HISTORIC AND DESIGN REVIEW COMMISSION

April 19, 2017

HDRC CASE NO: 2017-177
ADDRESS: 151 E TRAVIS ST
LEGAL DESCRIPTION: NCB 403 BLK 14 LOT W IRR 148 OF 8 & 9 ARB AB9
ZONING: D, RIO-3
CITY COUNCIL DIST.: 1
LANDMARK: Travis Building
APPLICANT: Adam Reed/Ford, Powell & Carson
OWNER: Mark Wyant/Seaside Hospitality Corporation
TYPE OF WORK: Construction of a seven story hotel
REQUEST:

The applicant is requesting conceptual approval to construct a seven story hotel at 151 E Travis on the San Antonio River Walk. The proposed hotel will feature 100 rooms, a restaurant at street level and a double height bar and lounge at the river level.

RIVER LEVEL
FLOOR PLAN

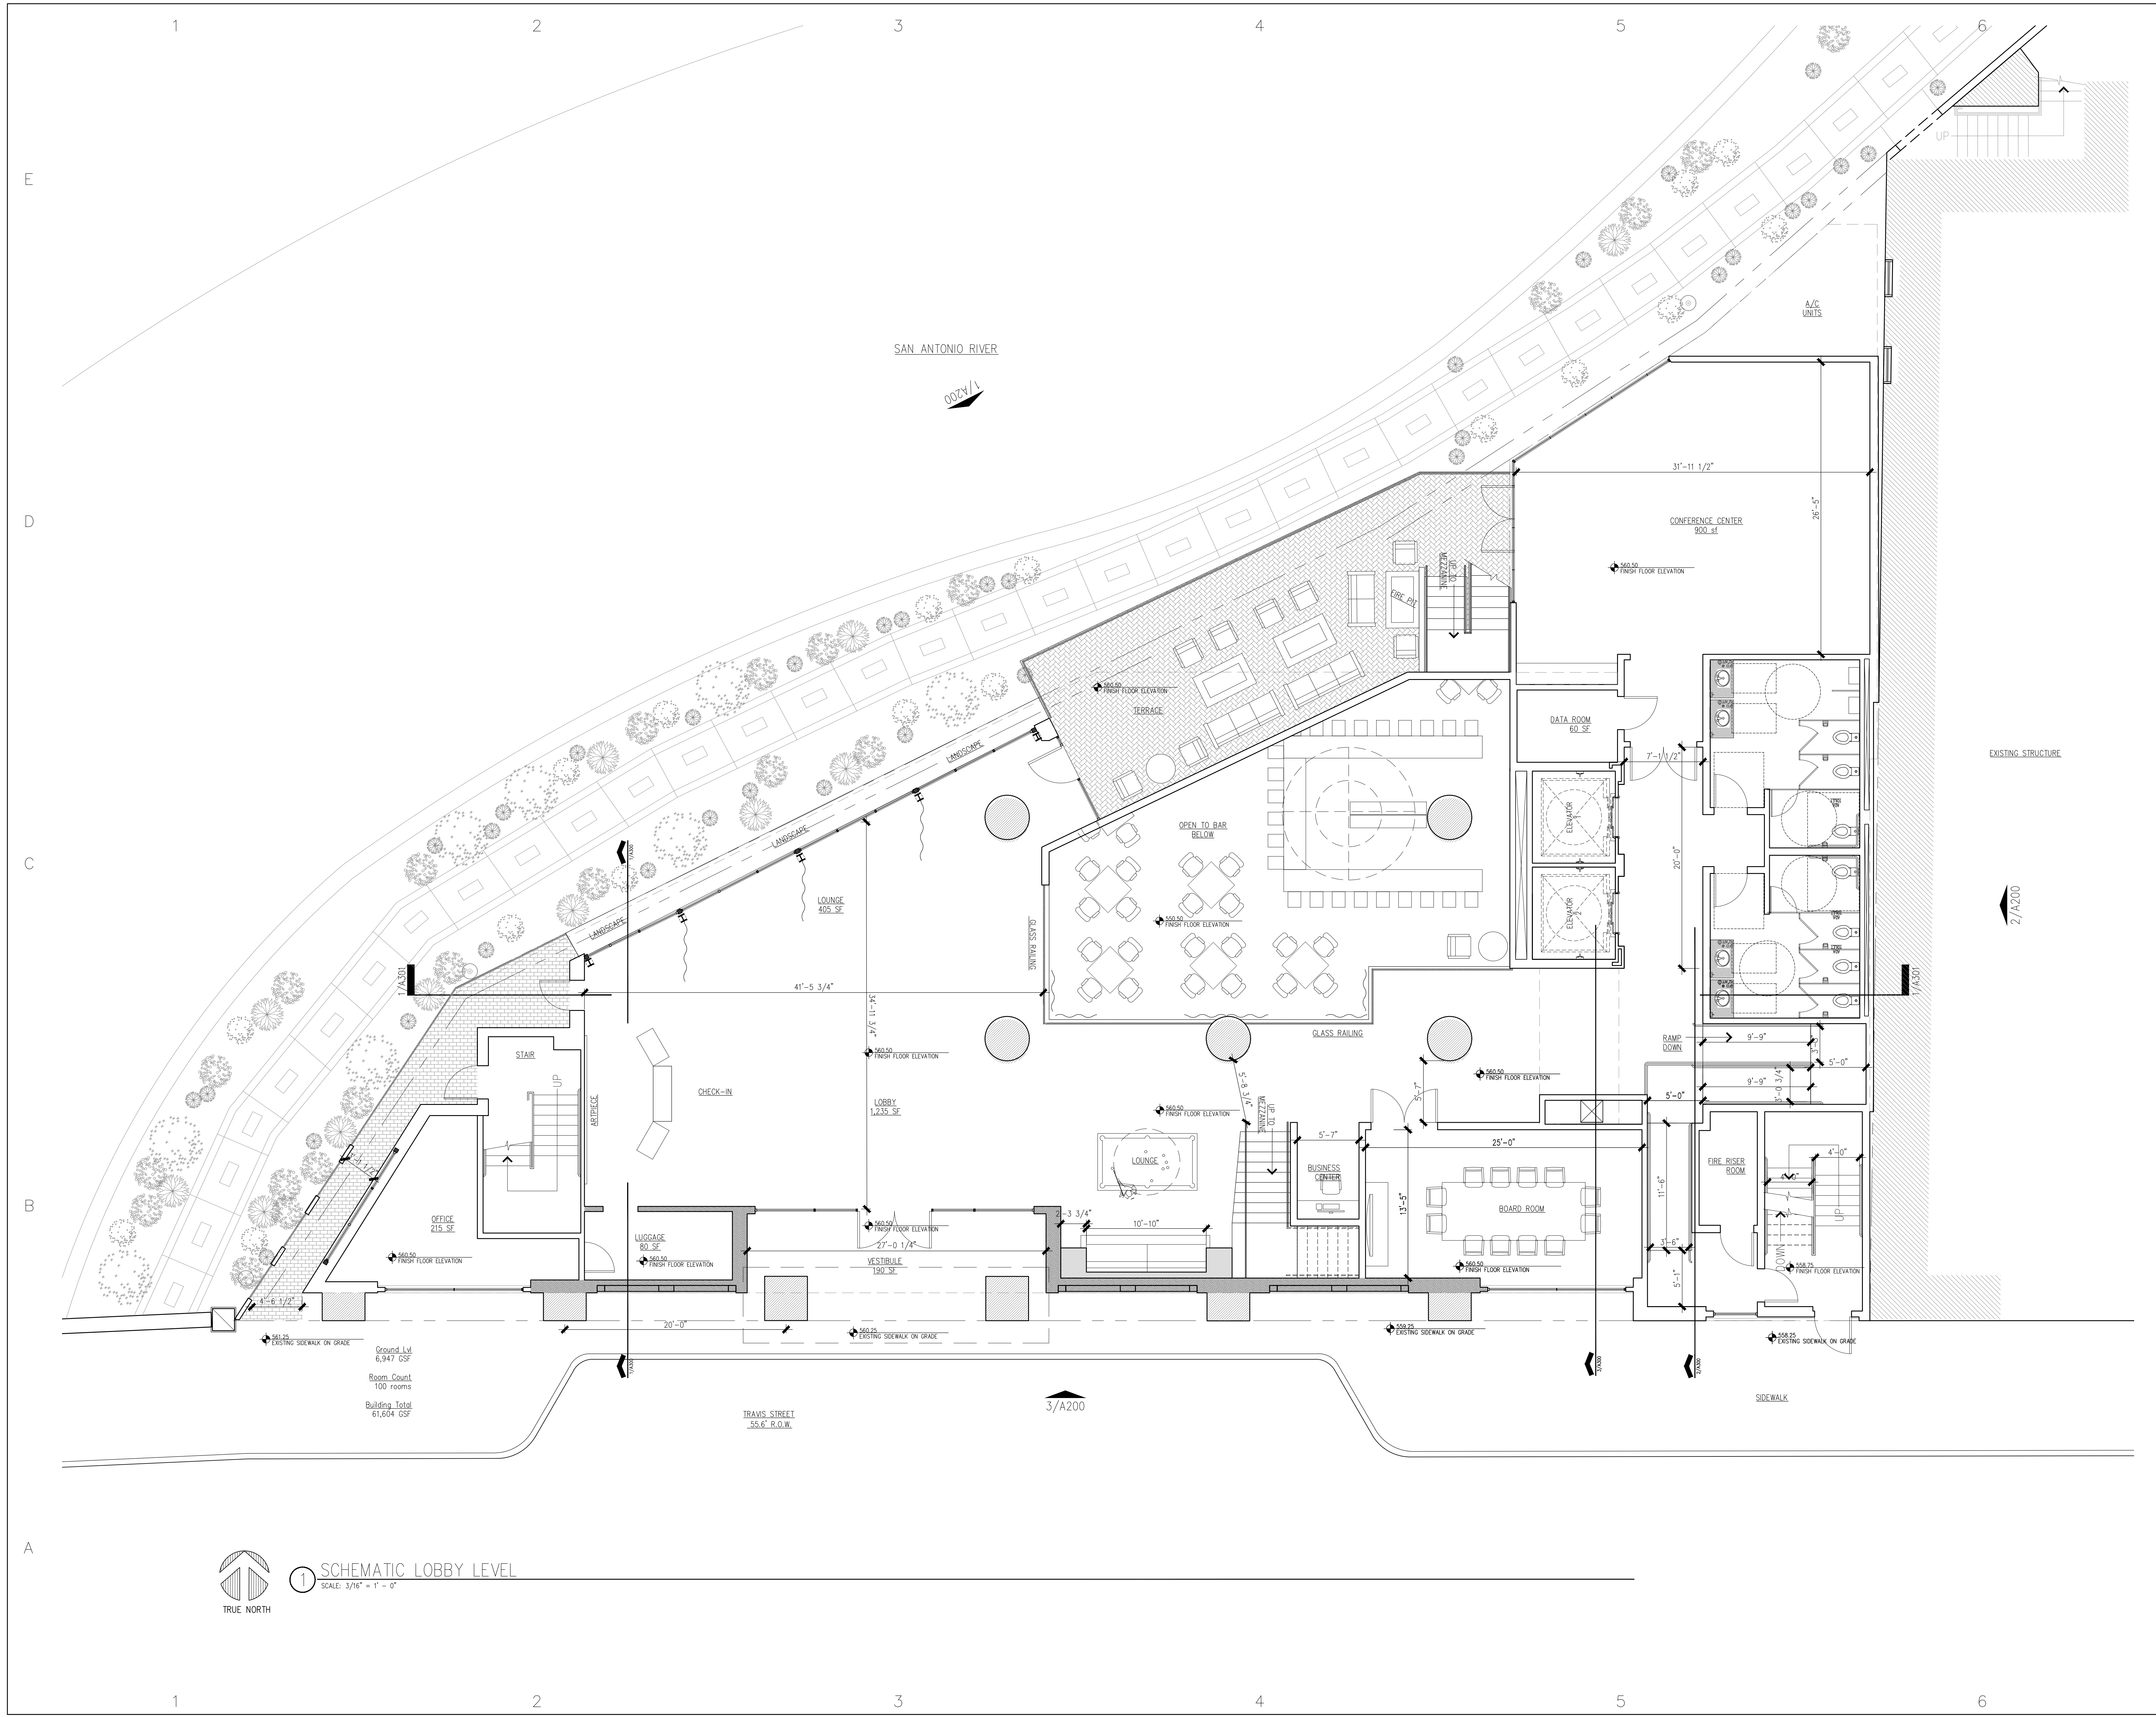
- o. **CANTILEVER** – The applicant has proposed a cantilever over the public right of way at the River Walk level. The proposed cantilever will not extend over the existing walkway at the River Walk level; however, it will extend over landscaped areas that are part of the River Walk experience. Staff finds that the applicant should provide additional information regarding the proposed overhang as well as information noting that the pedestrian experience at the River Walk will not be negative impacted.

① SCHEMATIC RIVER ELEVATION LOOKING SOUTH
SCALE: 3/32" = 1' - 0"

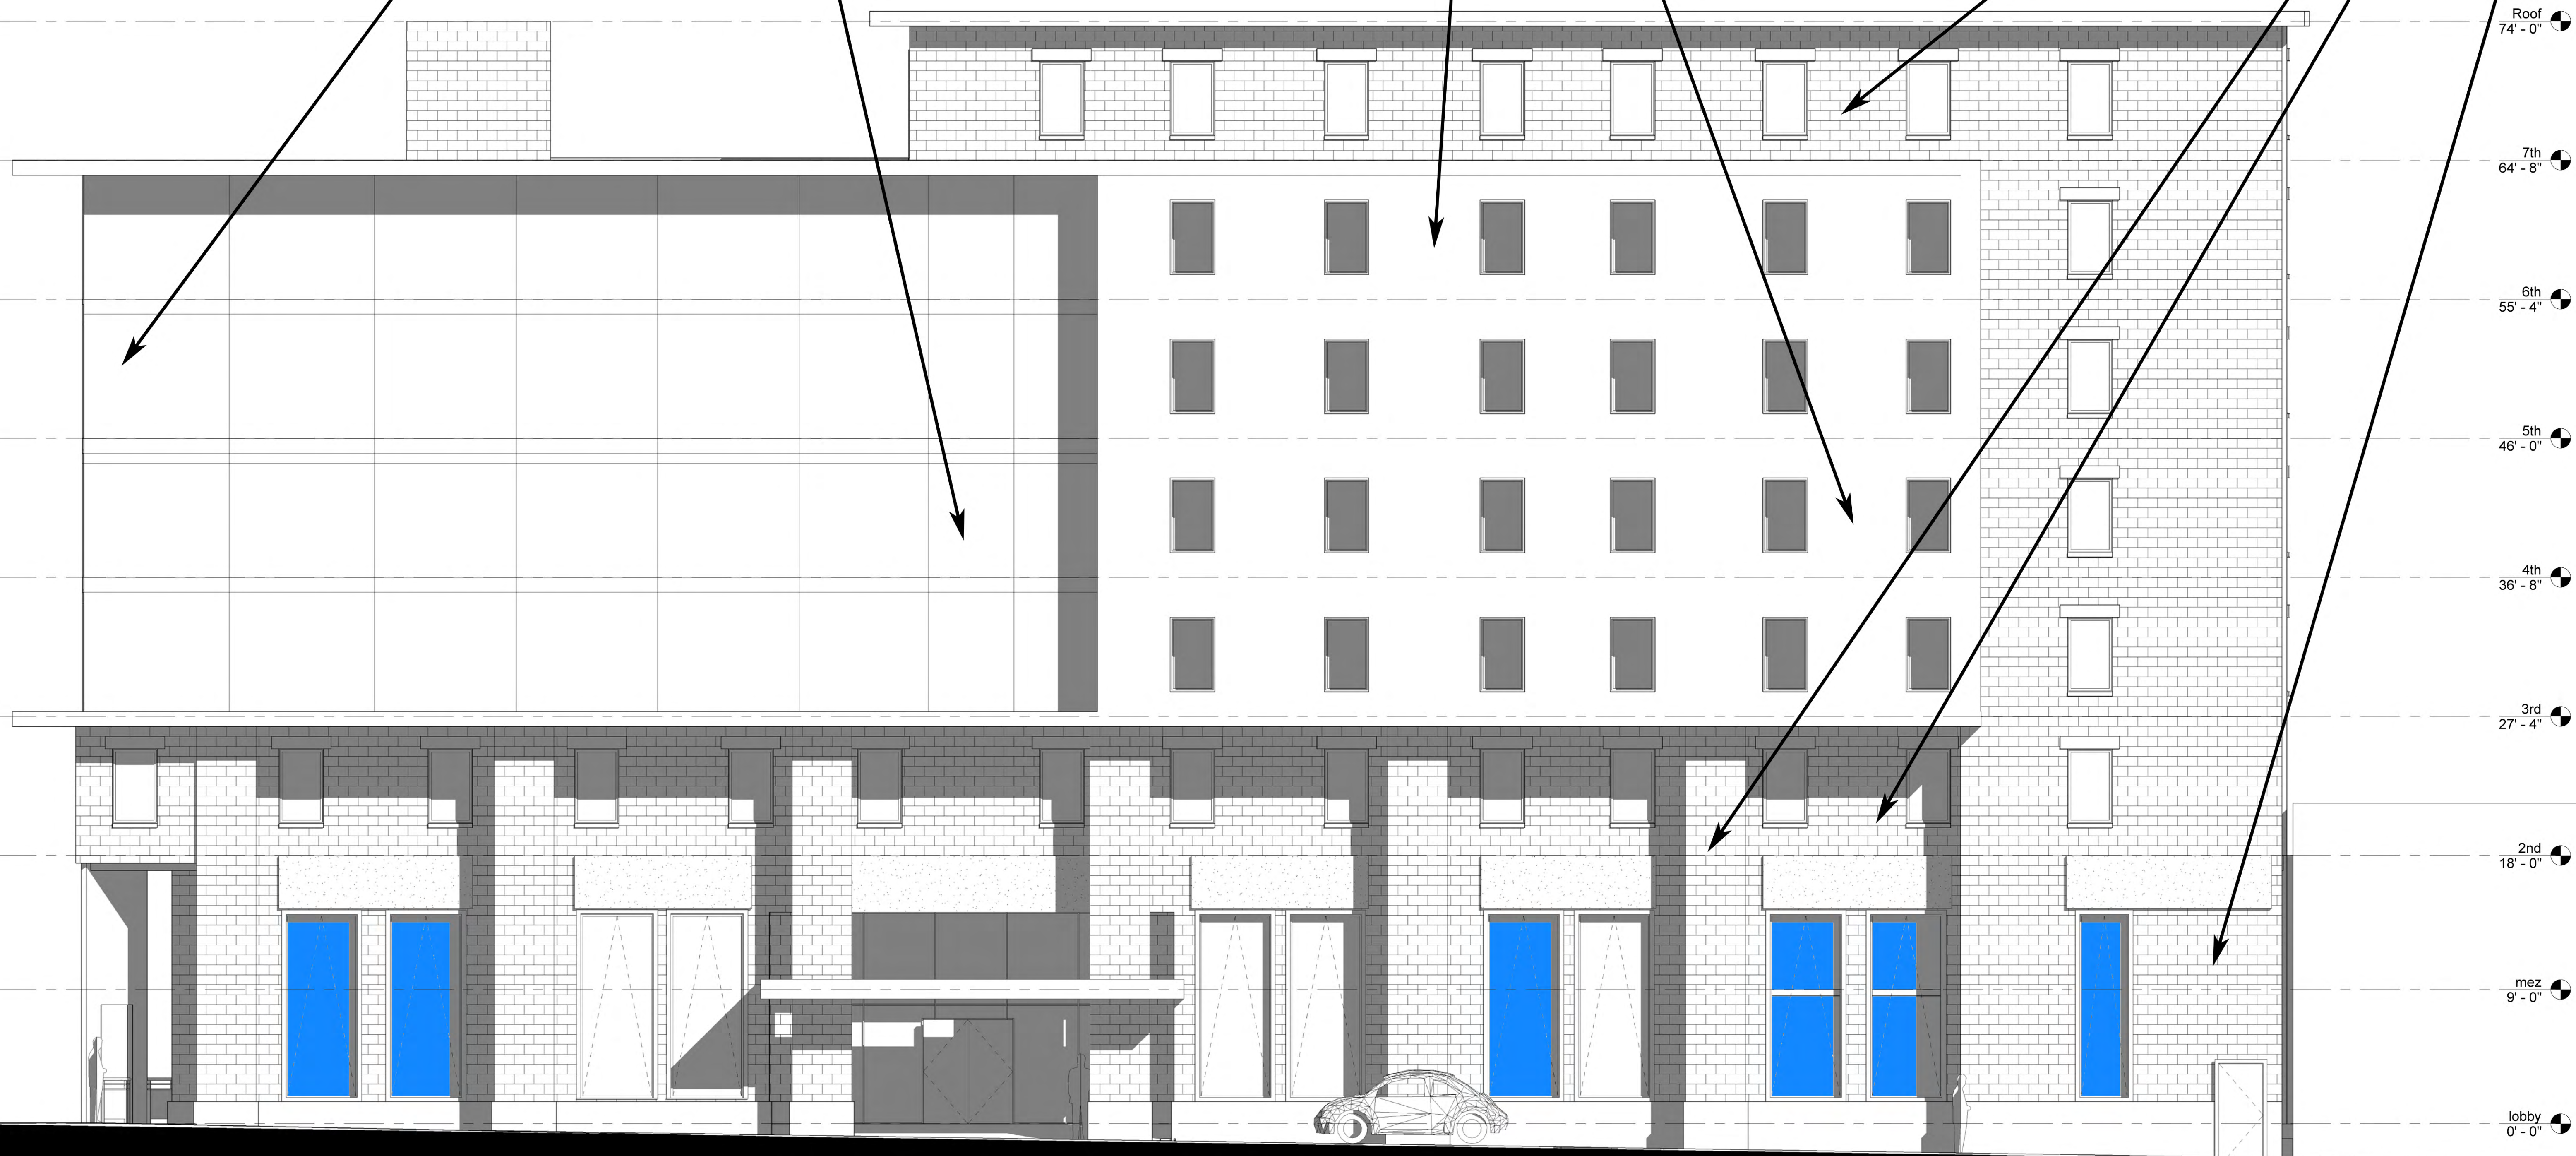
- l. **BUILDING SCALE** – According to the UDC Section 35-674(b) a building shall appear to have a “human scale”. To comply with this, a building must (1) express façade components in ways that will help to establish building scale, (2) align horizontal building elements with others in the blockface to establish building scale, (3) express the distinction between upper and lower levels, (4) in this instance, divide the façade of the building into modules that express traditional and (5) organize the mass of a building to provide solar access to the river. The applicant has proposed human scaled floor heights, materials, such as brick which portray a human scale, a human scaled entrance canopy and human scaled window openings.
